Permit Application No.: **16-631**

Rules: **Erosion Control, Stormwater Management, Wetland Protection, and Variance**

Applicant: **Woodridge Church**  
Project: **Woodridge Church Building Addition**  
Location: **1500 County Road 24, Medina**

**Recommendation:**

GRADING &  
 EROSION  
 CONTROL PLAN  
**C3-1**

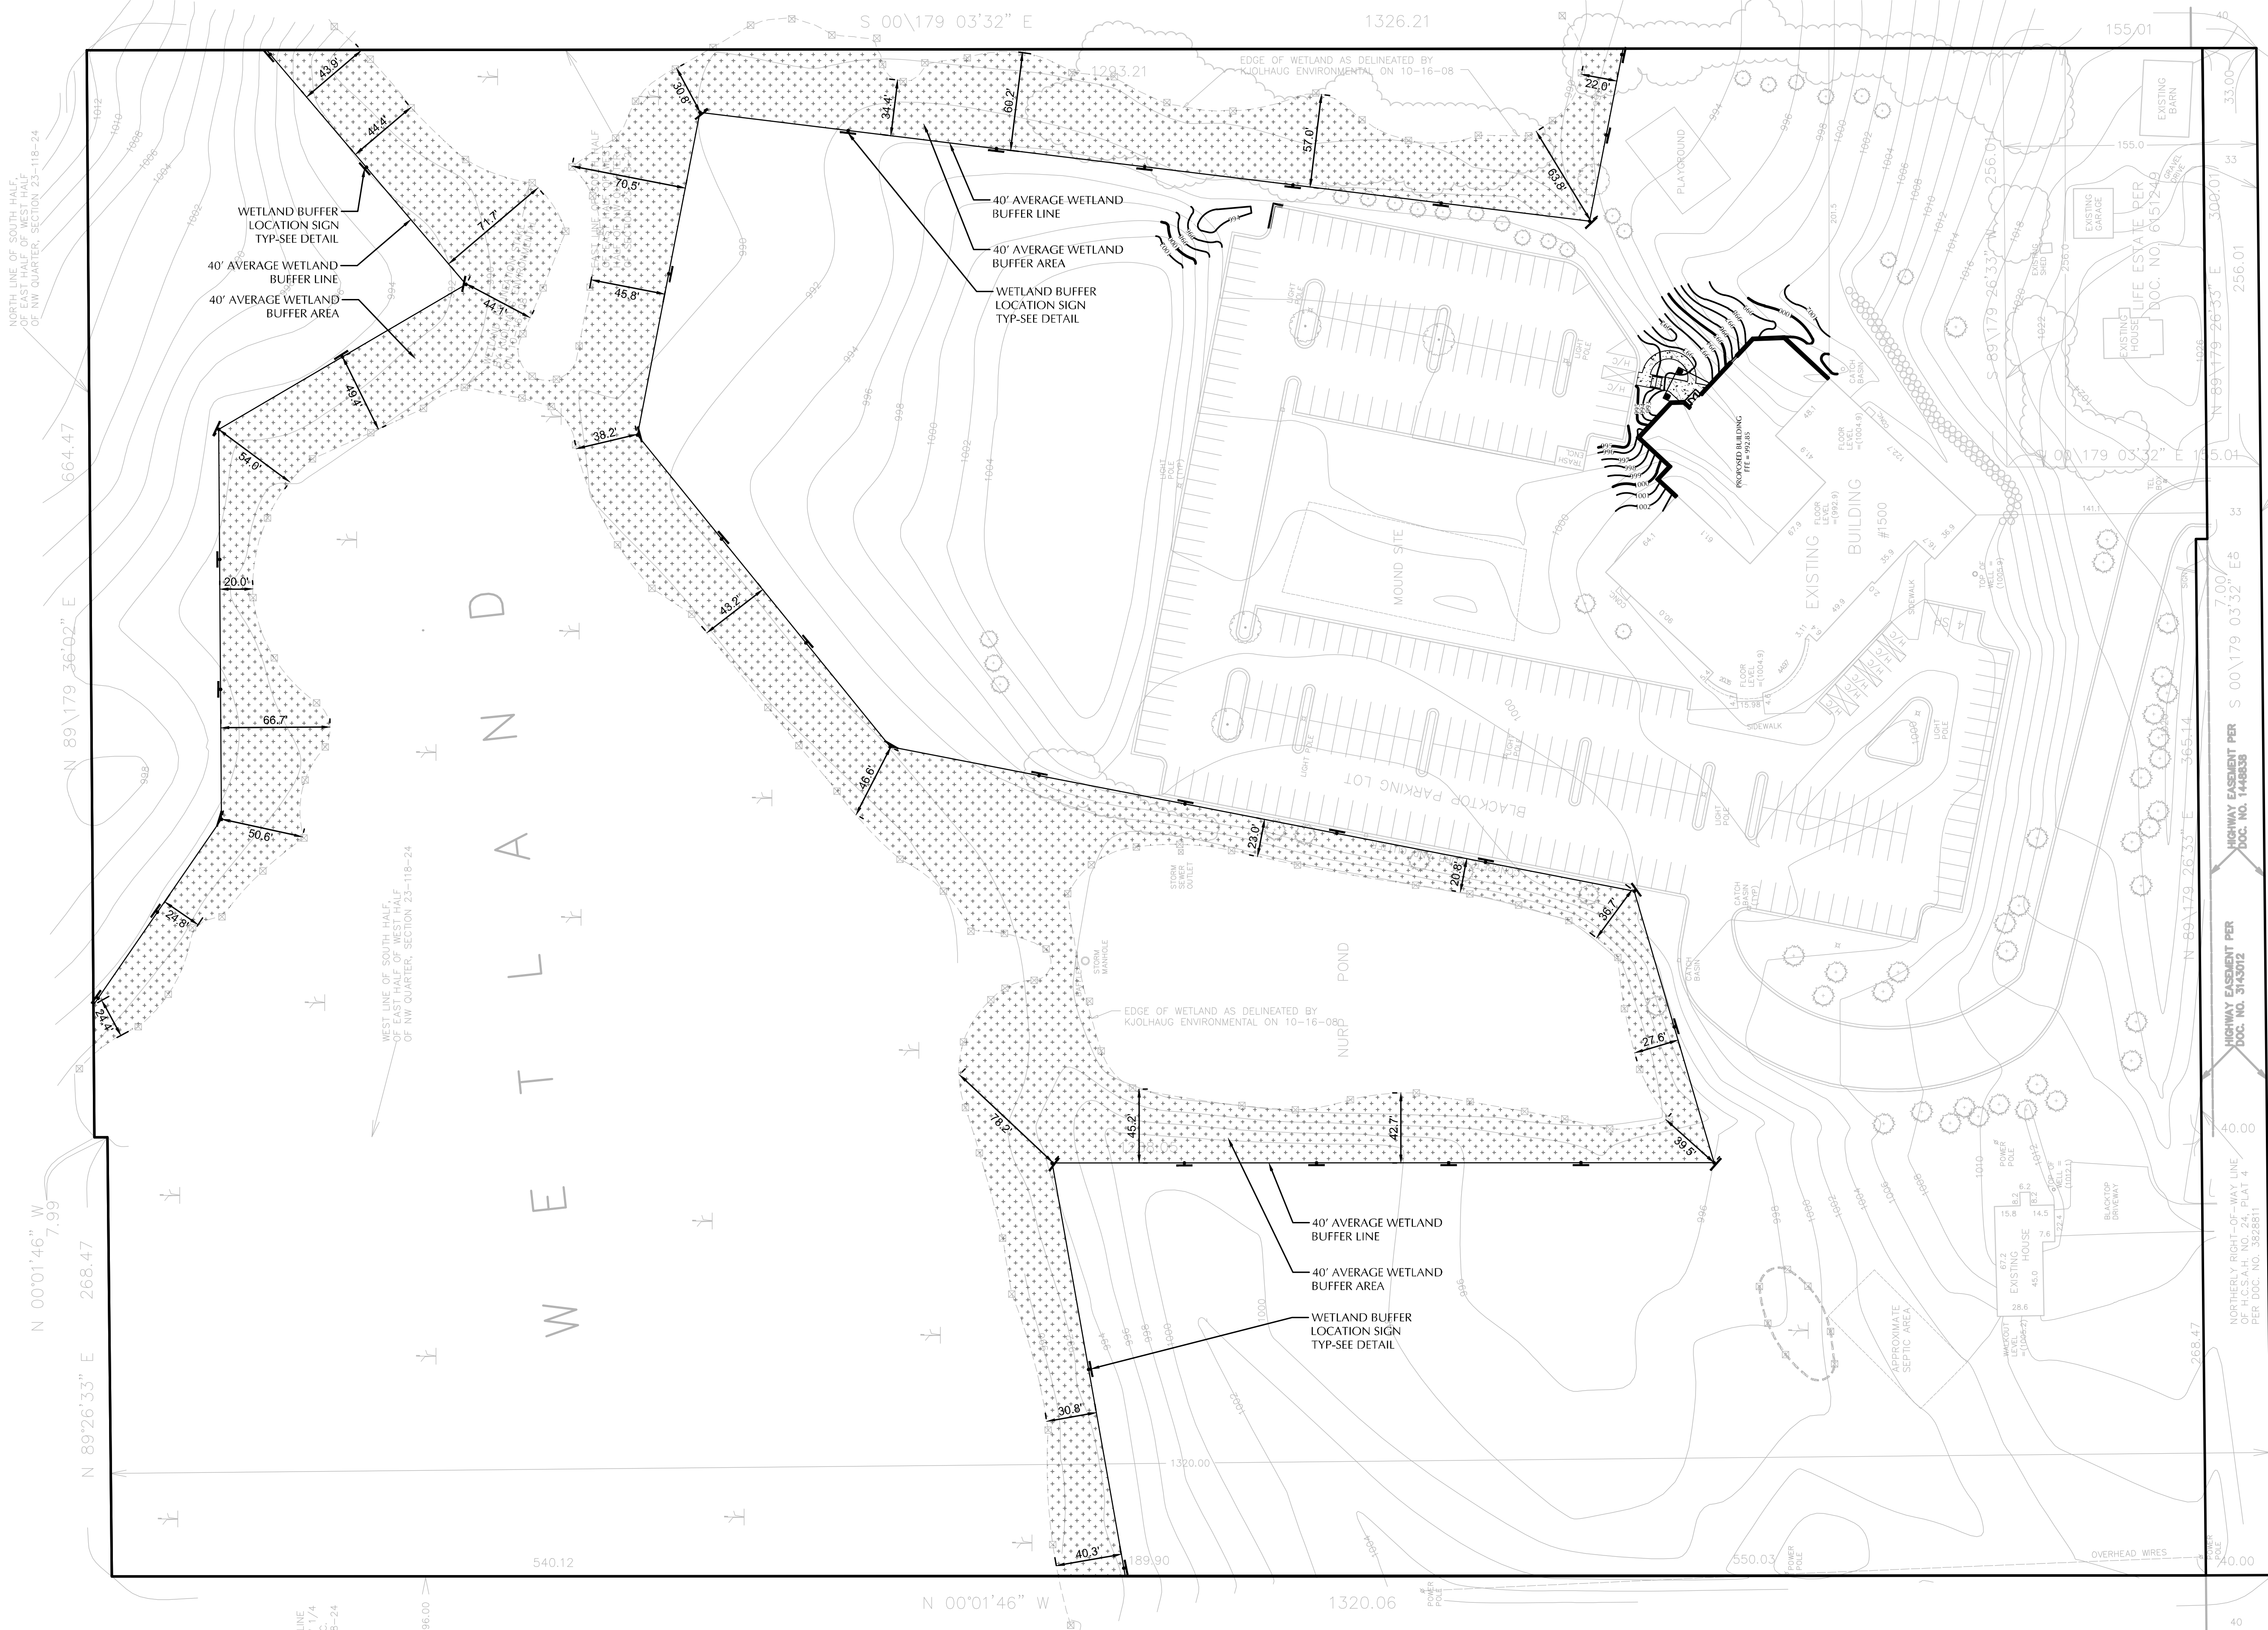
Erosion control best management practices including silt fence, inlet protection, street sweeping, and tree protection are provided where necessary to ensure erosion and sediment control. Concrete washout will be off-site. An NPDES permit is not needed because less than one acre of land disturbance is proposed.

To meet the District's volume control rule, the applicant must provide 801 cubic-feet of abstraction. Due to site constraints including poor soil, existing infrastructure, and low grades, the new impervious surface area cannot be routed to a treatment system. Instead, the applicant proposes to direct the runoff from the new impervious surface

area into an existing storm sewer system that outlets into a wetland that borders the property on the west (west wetland); a filtration system sized to provide 1,693 cubic-feet of abstraction will be installed to capture runoff from an existing, untreated parking lot that would otherwise drain to the west wetland<sup>1</sup>.
